Product Change Notification

PCN-AI-7532-2021

Business Unit	Product Line Code	Type of Change	Action	Date of Issue
AI - Automation Infrastructure	DNA	Product Change Notification	Notify Distributors and Field	12/21/2021

Change to the hardware revision of the items to optimize the field of application.

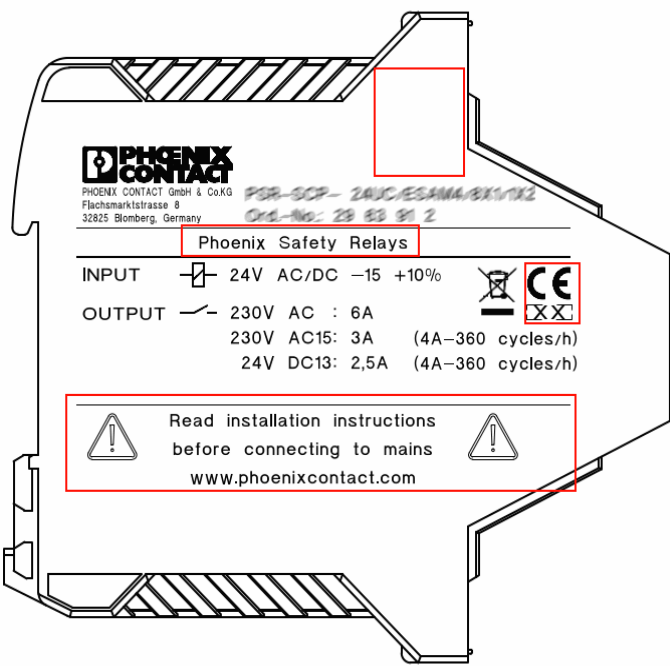
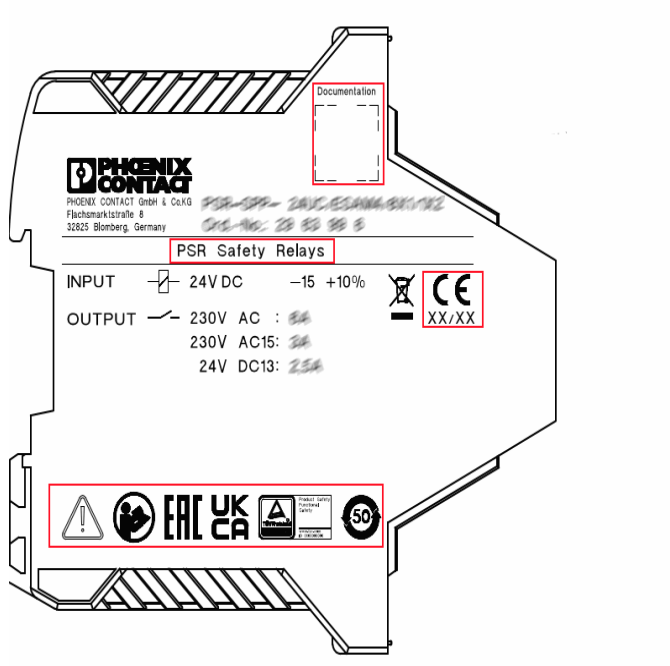
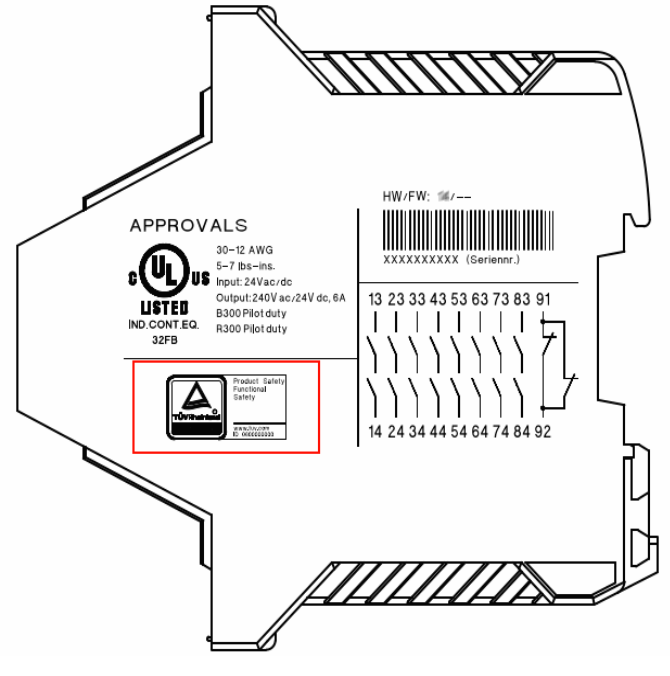
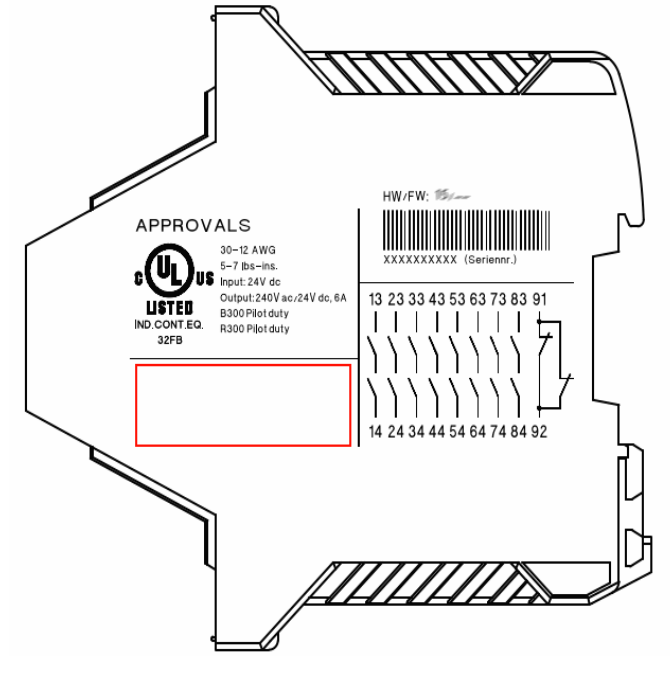
Due to the hardware change, the listed items can no longer be operated via an AC supply voltage, and are therefore only compatible with old item versions to a limited extent. The modified technical values are listed in the attachment. In addition, non-coded plugs will be installed, the packing slip will be changed over to a new documentation concept, and a smaller folding carton will be used.

In addition to the year of manufacture, the calendar week will also be displayed below the CE mark. The various pictograms and TÜV approvals will be displayed in the lower area on the left half of the housing; the plug will no longer be coded.
